ISSUE NO.: 02/92  
DATE: 6 MAY 1992  
FROM: C. SNELL / K. EDWARDS

SUBJECT: REPLACEMENT OF IMPELLERS AND MOTORS ON CONDENSING UNITS

UNITS: SCR 150, SCR 250

NOTE: SUPERCEDES ISSUE 6/87 AND 9/90

Fig. 1 Replacement Motor Assembly

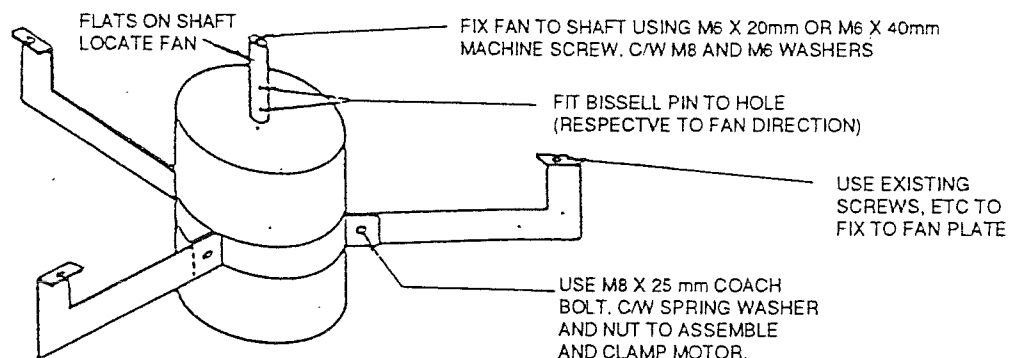
- (a) Should your unit be fitted with a 16" dia aluminium impeller and the old UE motor (on pre 1987 models) and either the impeller or the motor has failed then the entire assembly must be replaced (see Figures 1 and 2) by the following:

The final position of the motor/impeller assembly should leave 1/3 of the impeller beyond the bellmouth edge. See Figure 2.

<u>Item</u>	<u>Part Number</u>
Universal Electric Motor	021 046 000 129
16" Plastic Impeller	021 018 000 051
Plastic Fan Cap	021 018 000 052
Bissell Pin	021 060 000 035
Single Arm Fan Motor Bracket (one set)	022 018 154 001
M8 x 25mm long Coach Bolts (3 req'd)	Factory Supply
M8 Spring Washer (3 required)	Factory Supply
M8 Nuts (3 required)	Factory Supply
M6 x 40mm long Machine Screw	Factory Supply
M8 Washer (81D x 20 OD)	Factory Supply
M6 Washer	Factory Supply

Fig.4 SCR 150 & 250 Wiring Diagram

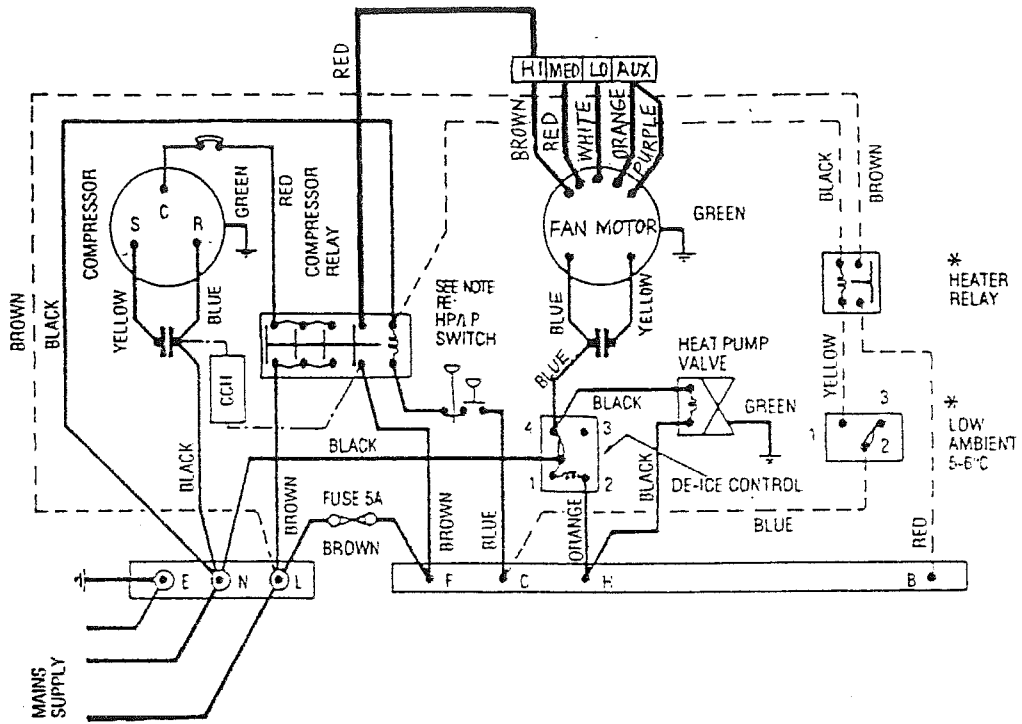
- (d) When replacing an Elco motor the existing capacitor is retained and either medium or low speed selected. The exception to this is when the condenser fan is speed controlled and in these cases the existing capacitor is replaced with a 2 mic capacitor, the motor as mentioned previously is put onto high speed.
